Subject: MHI's Responses to US-APWR DCD RAI No. 148-1700 Revision 1

Response to Request for Additional Information
No. 148-1700 Revision 1

US-APWR Design Certification

RAI NO.: NO. 148-1700 REVISION 1

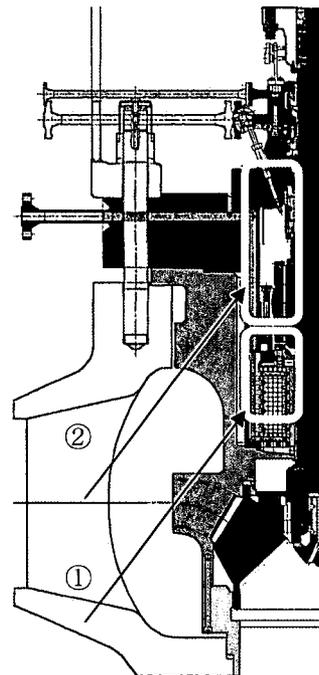
The modeling of Reactor Coolant Pump (RCP) seal LOCAs in the US-APWR PRA are discussed in Appendix 6A.14.2 of Revision 1 of the PRA report. It is stated: "New type O-ring which is improved for resistance to heat and pressure will be used in the USAPWR. But the RCP seal LOCA model for the US-APWR conservatively uses a mode[] for the old type O-ring." However, the old O-ring model was modified by assuming that the maximum leak rate of 480 gpm per RCP will occur if cooling of the seals is lost for more than one hour. Although the assumed leak rate is very conservative (even according to the old O-ring model), the assumption that the RCP seal adopted by the US-APWR can keep its integrity for at least one hour without water cooling is not consistent with either the new or the old O-ring model. According to these models, there is a small probability (about 5E-3) that a leak rate of 480 gpm will develop within 10 to 30 minutes following loss of seal cooling. Please provide a more detailed discussion and the reason for using this "modified" old O-ring model in the US-APWR PRA as well as the basis for the assumption that the adopted RCP seal can keep its integrity for at least one hour without water cooling.

At the SBO, the RCP will be stopped, and supply of the seal injection water and cooling water will be stopped. The low-temperature injection water stored in the pump will be drained to the outside of the pump as the leakage water from the seal, and the high-temperature RCS water will be fed into the pump. As described above, since the high-temperature water is fed into the pump, the temperature of the seal will rise. We have, therefore, examined whether the seal temperature rises to the dangerous point where the shaft seal function can be deteriorated. This document shows the result of this examination.

In the actual RCP, the high-temperature RCS water is fed into area ① shown in the right figure. The water is then mixed and fed into the upper area, and finally, the shaft seal inlet at the top of area ② will be heated.

We set the seal injection water capacity (areas ①+ ② in the right figure) to 518lbm(235kg,235L), and assumed that the high-temperature RCS water fed into the seal injection water area would be immediately mixed with the seal injection water of the above capacity to uniform the temperature.
